Preliminary Acceptance PA Punchlist
EPC - DPW - Stormwater Section

Project Name:	Paint Brush Hills F14
EDARP Filing Number(s):	SF2024, CON2158
ESQCP Number:	ESQ2110
Attendees:	DPW SW: Dylan Finley, Joshua Augustenborg, Ben Jones, DPW Planning: David Parkerson, Amanda Rivera Developer: Jeff Mark, Chris
Date of Walk-Thru:	03-07-2023
Walk-Thru Number:	1

Photo 6: Remove excess concrete from forebay weir notch which is restricting flow.

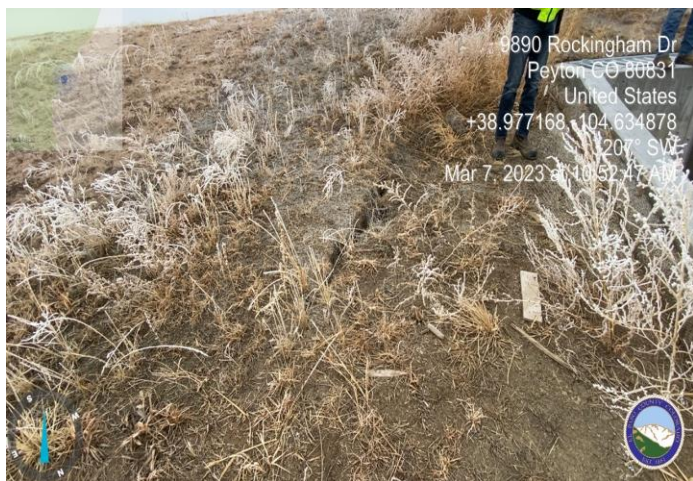
- Remove all weeds from the emergency spillway.
- Remove weeds from pond embankments and pond bottom.
- Lower pond bottom to top of trickle channel curb with a 3% slope towards trickle channel for positive drainage.
- Rill erosion occurring on pond embankments. Regrade and stabilize.
- Install maintenance road per plan detail. (Calls for CDOT Class 2 road base)
- Install gasket or calking around orifice plate.
- Remove excess concrete from forebay notch that is restricting flow (see Photo 6)
